Addendum

Project No: 220937
Project Name: PG-UHN Trayline Assembly System Replacement

Date: March 1, 2023
AD No: 01

MECHANICAL ADDENDUM # 01

Project
UHN TRAYLINE ASSEMBLY SYSTEM
REPLACEMENT
1475 EDMONTON STREET, PRINCE GEORGE, BC, V2M 1S2
Drawing
MECHANICAL SCHEDULES
Project Number
22306
Sheet Number
M400

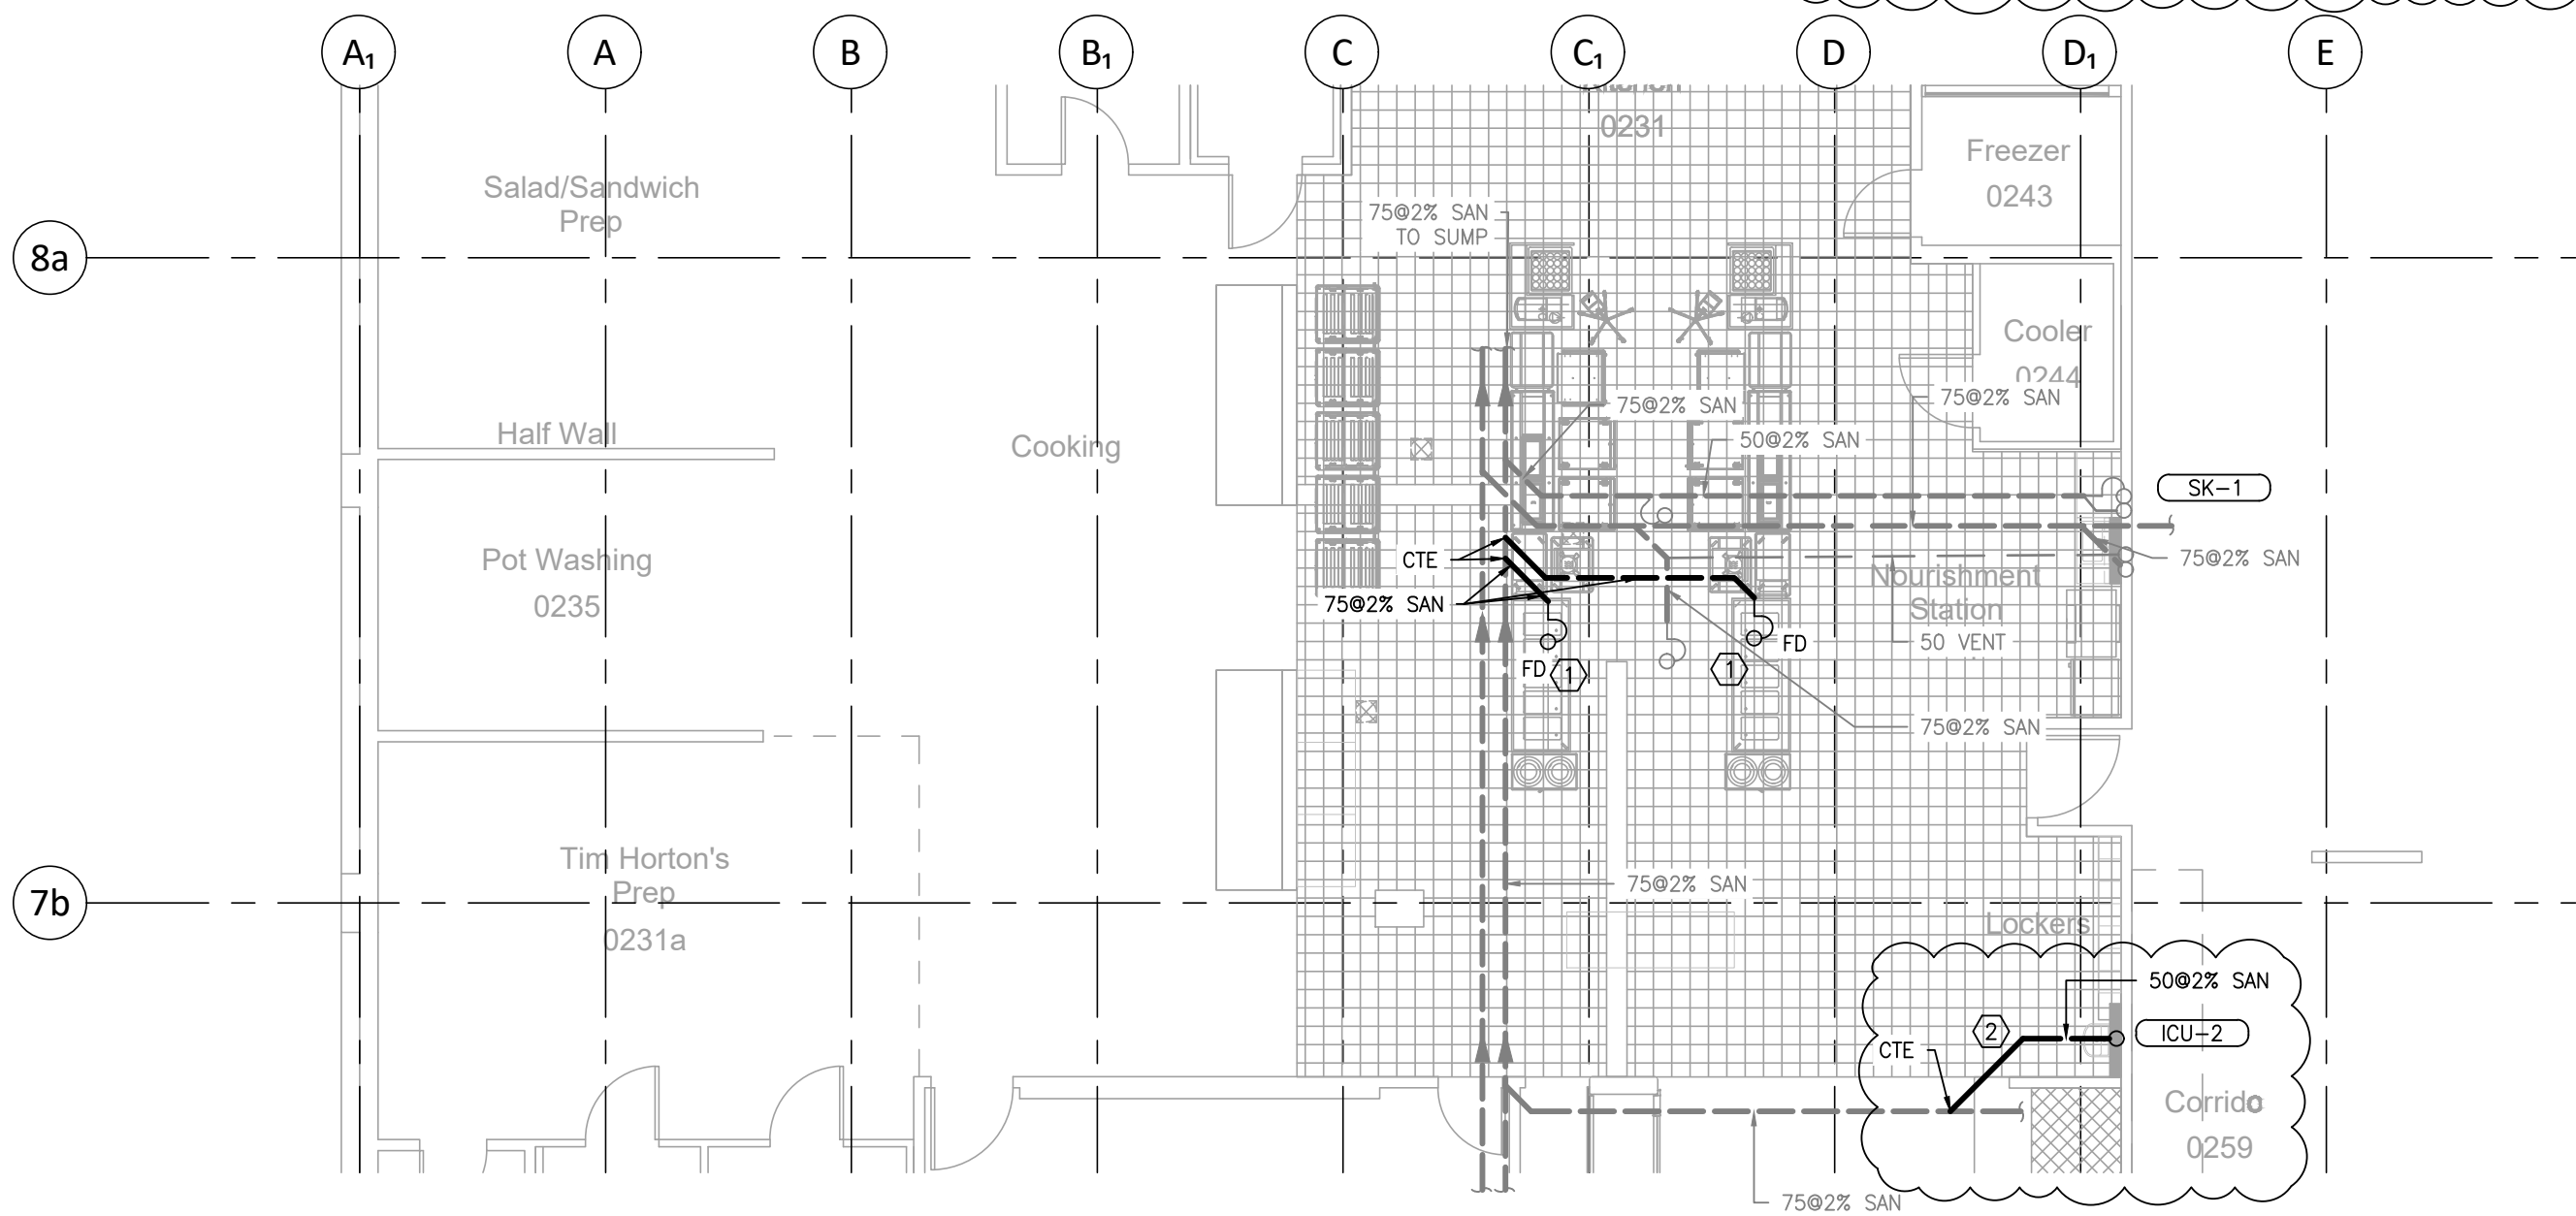
Contractor to allow for saw cutting of the existing concrete slab, removal of the slab, and making good the existing slab to accommodate the new mechanical drainage lines. Refer also to sheet M400 for new mechanical drainage piping locations.

Reference: Mechanical drawings M111, M113 and M400
Delete
 Existing drawings M111, M113 and M400
Add
 Revised mechanical drawings M111 and M400 are reissued. (see attached)

Reference: Mechanical drawing M112
Add
Demolition Notes
 Item # 3 Existing eye wash and sink to be turned over to NH – Plant Operations
 Item # 6 Remove existing water line, water filter, and drain lines to existing Ice machine to allow installation of wall protection.
Renovation Notes
 Item # 10
 Delete: Sink and trim will be part of millwork supplied by others.
 Add: Sink and trim to be supplied in this contract (see plumbing equipment schedule on reissued drawing M400.
